ARCHITECT'S SUPPLEMENTAL INSTRUCTIONS

PROJECT: Bear Claw II Exterior Remodel
2420 Ski Trail Lane
Steamboat Springs, CO 80487

ASI NO: 008

Ski Entry existing slab damage structural repair in response to MCP RFI #012 dated 2019-06-19.

Sheet Number
S102

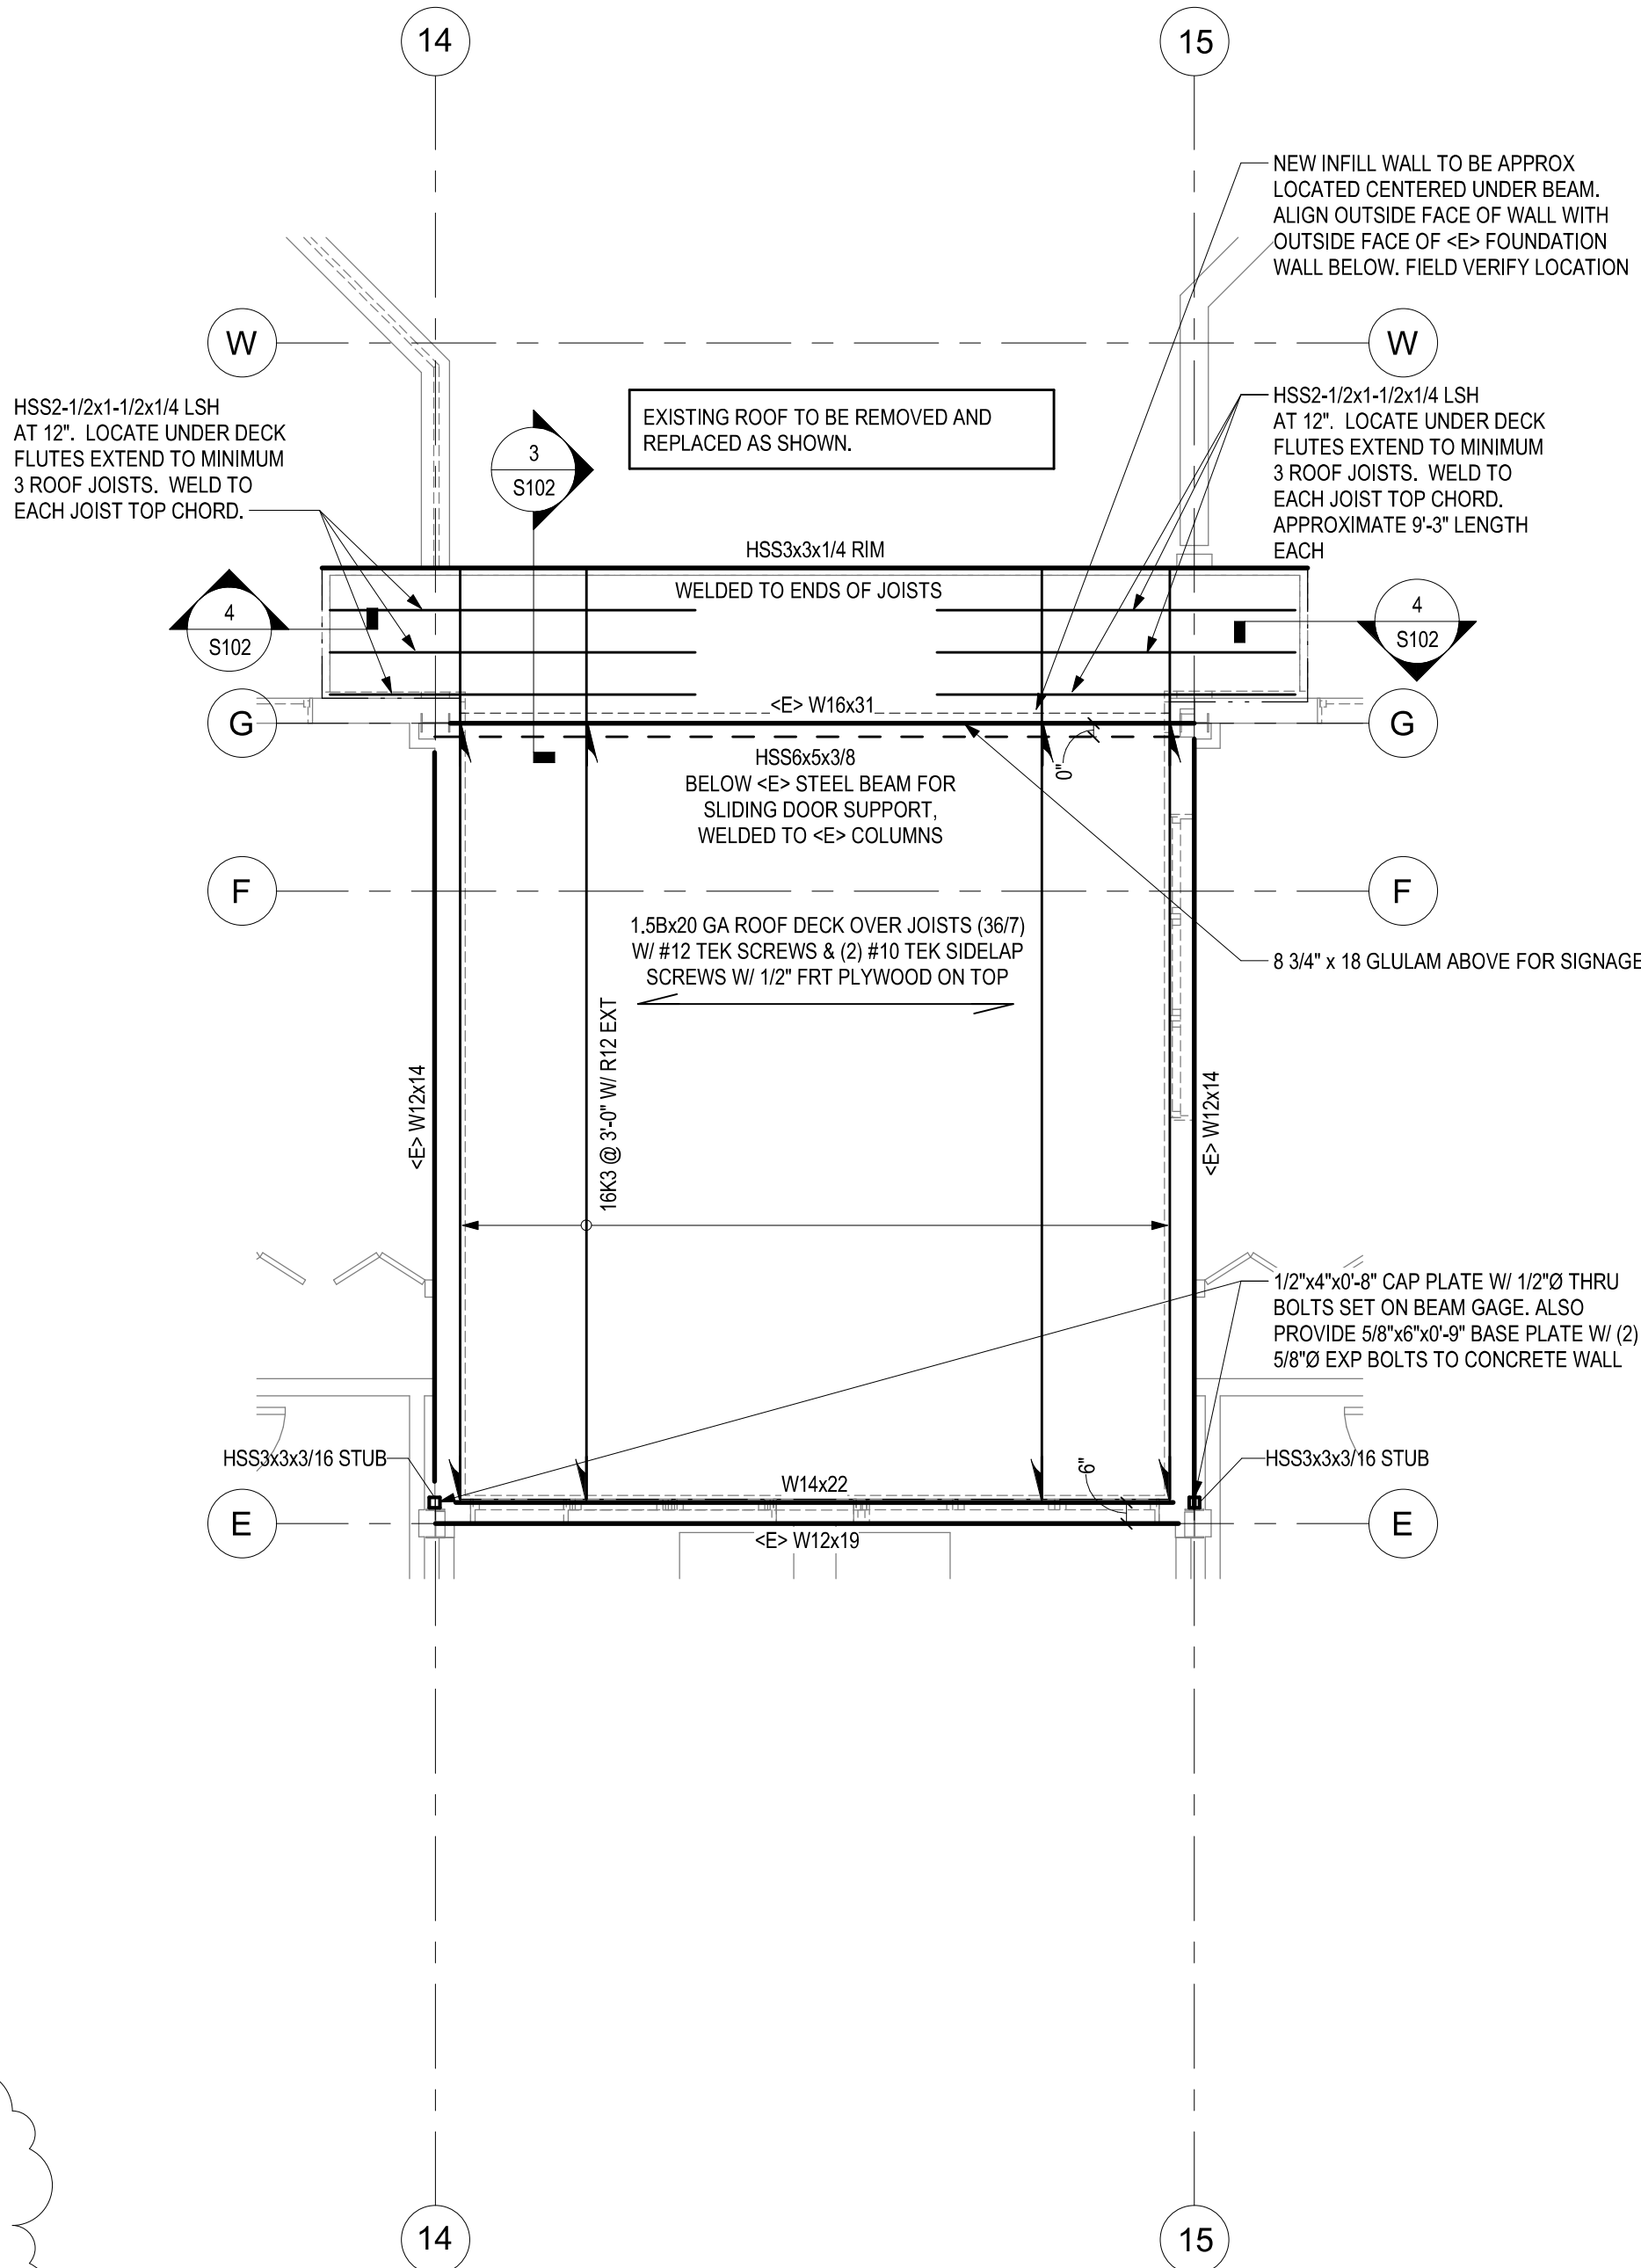
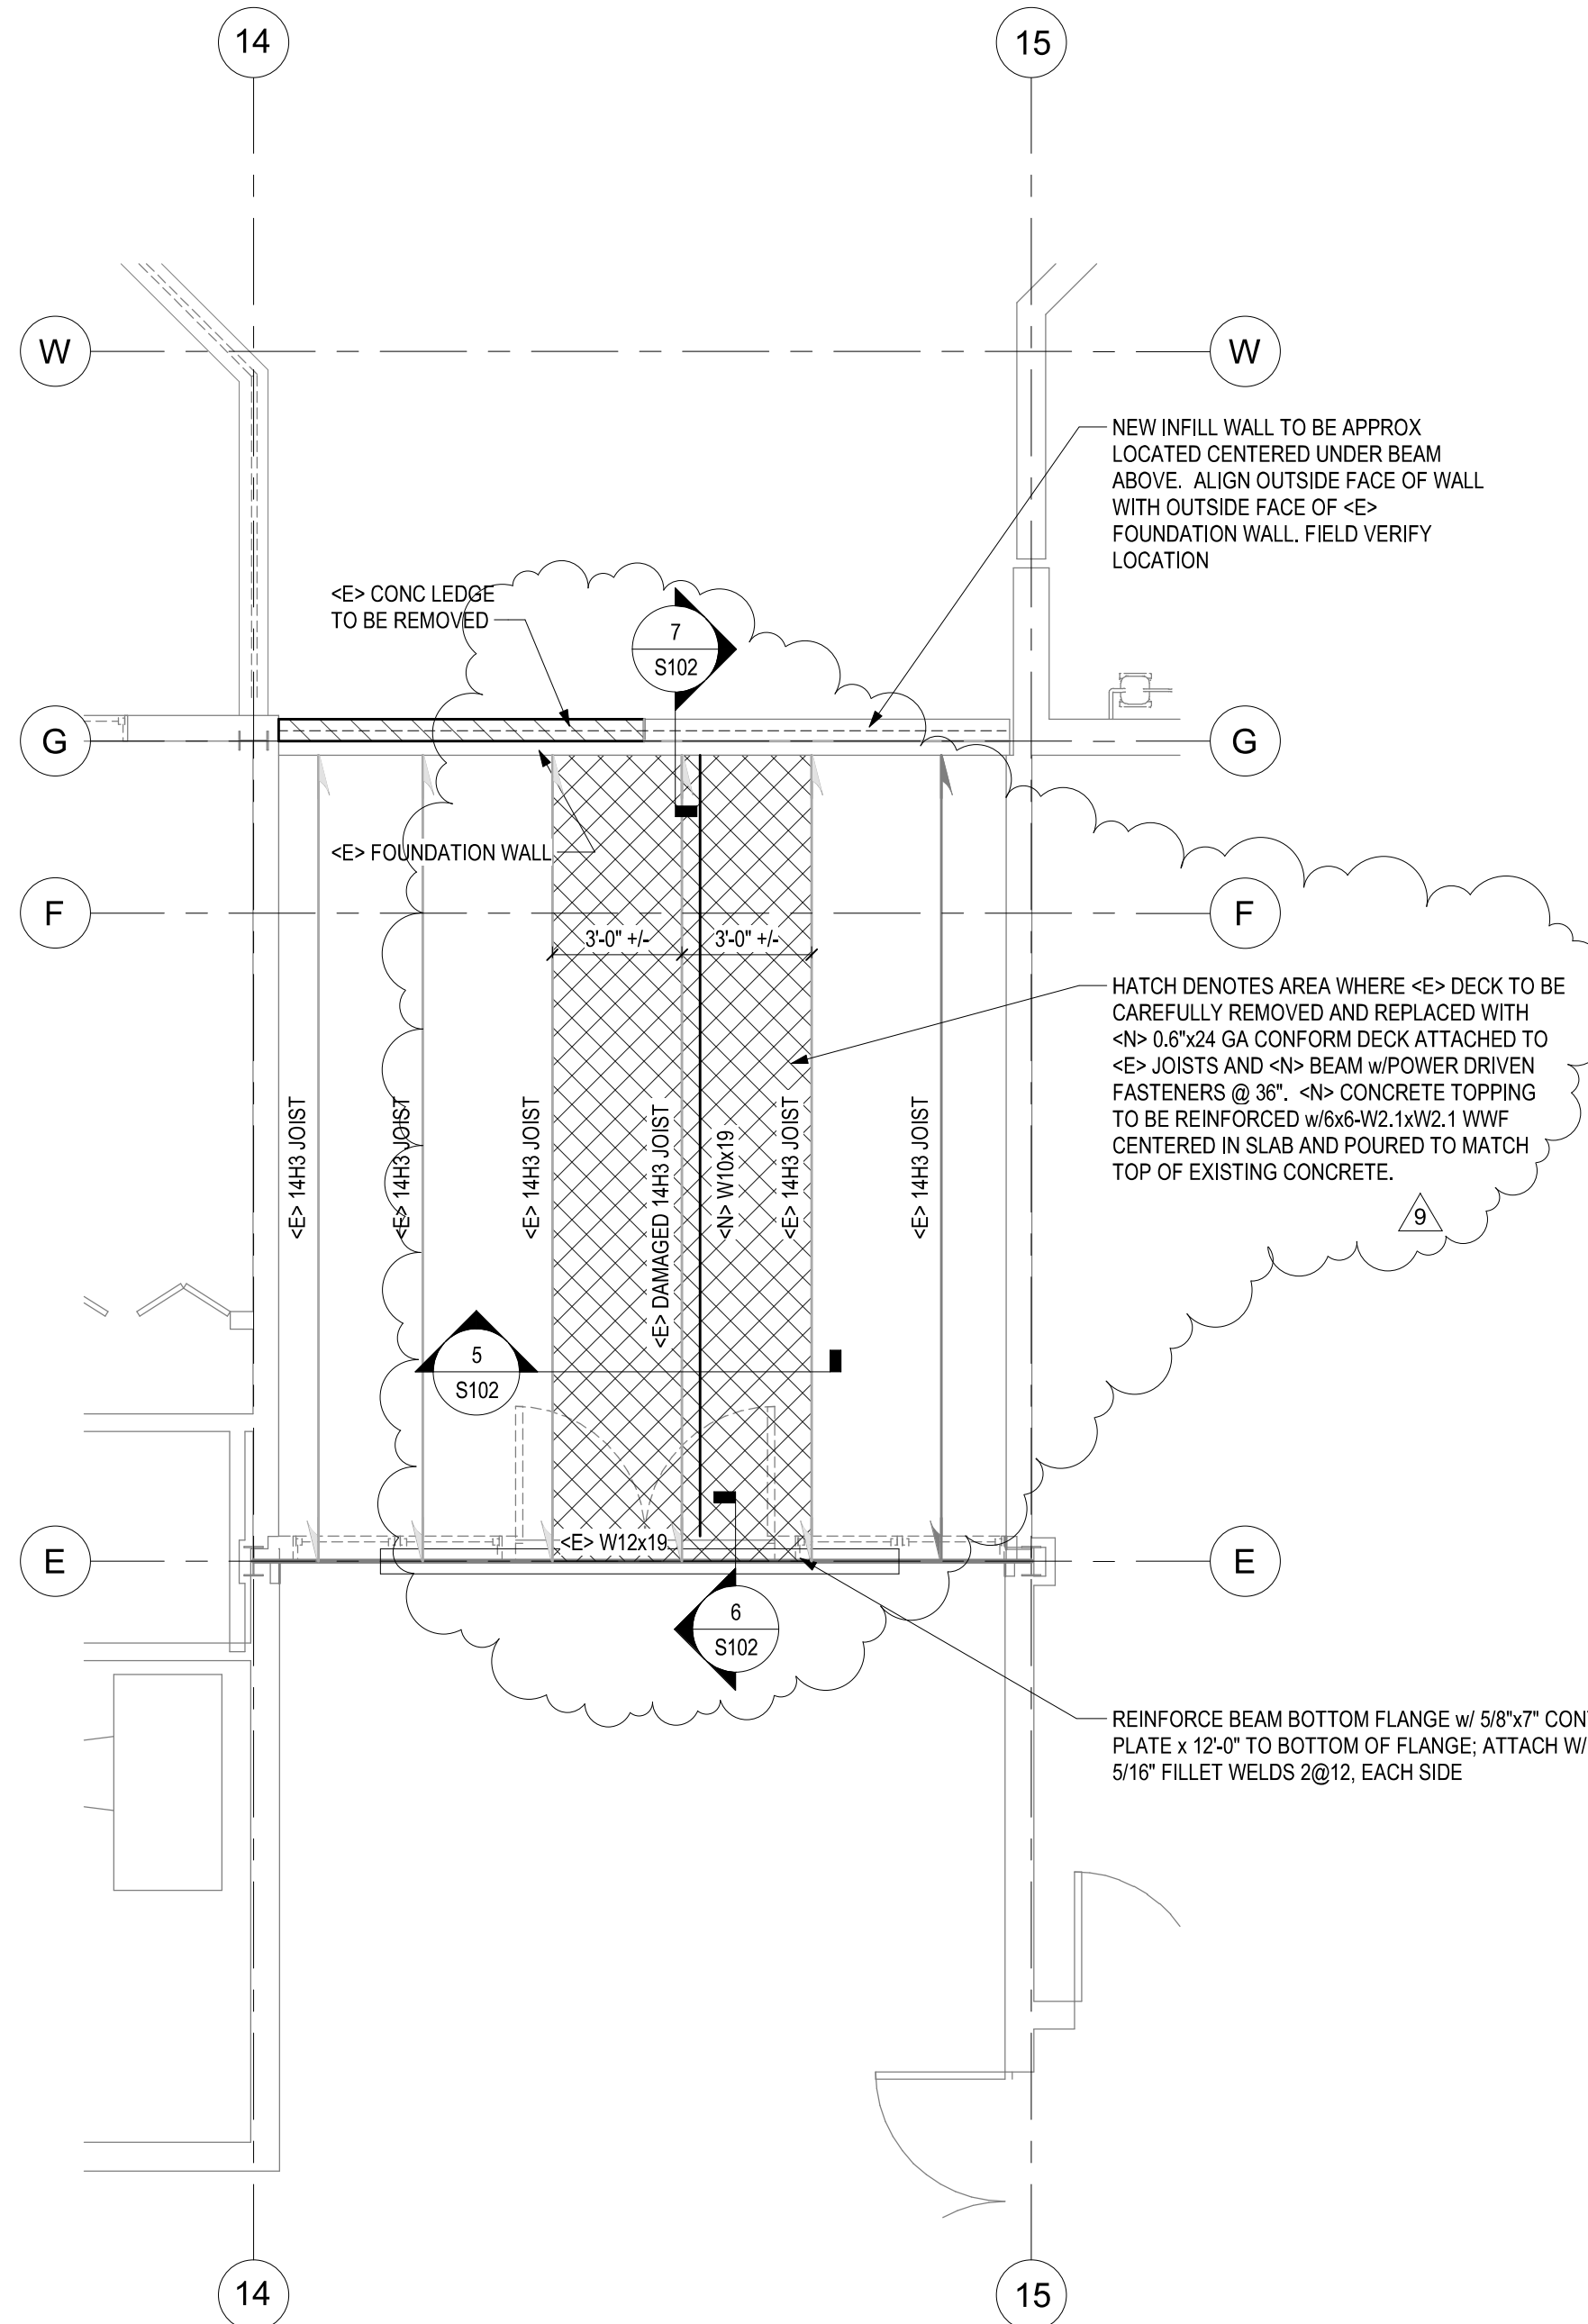
NEW INFILL WALL TO BE APPROX LOCATED CENTERED UNDER BEAM ABOVE. ALIGN OUTSIDE FACE OF WALL WITH OUTSIDE FACE OF <E> FOUNDATION WALL, FIELD VERIFY LOCATION

<E> CONC LEDGE TO BE REMOVED

HATCH DENOTES AREA WHERE <E> DECK TO BE CAREFULLY REMOVED AND REPLACED WITH <N> 0.6"x24 GA CONFORM DECK ATTACHED TO <E> JOISTS AND <N> BEAM w/POWER DRIVEN FASTENERS @ 36". <N> CONCRETE TOPPING TO BE REINFORCED w/6x6-W2.1xW2.1 WWF CENTERED IN SLAB AND POURED TO MATCH TOP OF EXISTING CONCRETE.

REINFORCE BEAM BOTTOM FLANGE w/ 5/8"x7" CONT PLATE x 12'-0" TO BOTTOM OF FLANGE; ATTACH w/ 5/16" FILLET WELDS 2@12, EACH SIDE

<N> BEAM PER PLAN
<N> DECK AND TOPPING PER PLAN, BEAR DECK ON 1/2 OF <E> JOIST TOP CHORD AND FASTEN PER PLAN
NEATLY CUT <E> CONCRETE TOPPING AT CL <E> ADJACENT JOISTS. DO NOT CUT <E> JOIST
5"
<E> UNDAMAGED JOISTS TO REMAIN
DAMAGED JOIST, CONTRACTOR OPTION TO PLACE <N>BEAM WITHIN 5" AND LEAVE DAMAGED JOIST IN PLACE

<E> FLOOR JOIST, VIF
<N> BEAM, SEE PLAN COPE TOP FLANGE AS REQ'D TO MATCH TOP OF <E> JOISTS
<E> BEAM SEE PLAN FOR REINFORCEMENT REQUIREMENTS
3/16
3/16 PL TO BEAM
3/8"x4"x0'-6" SHEAR PLATE w/(2)-3/4"Ø A325 BOLTS IN HORIZONTAL SHORT SLOTTED HOLES
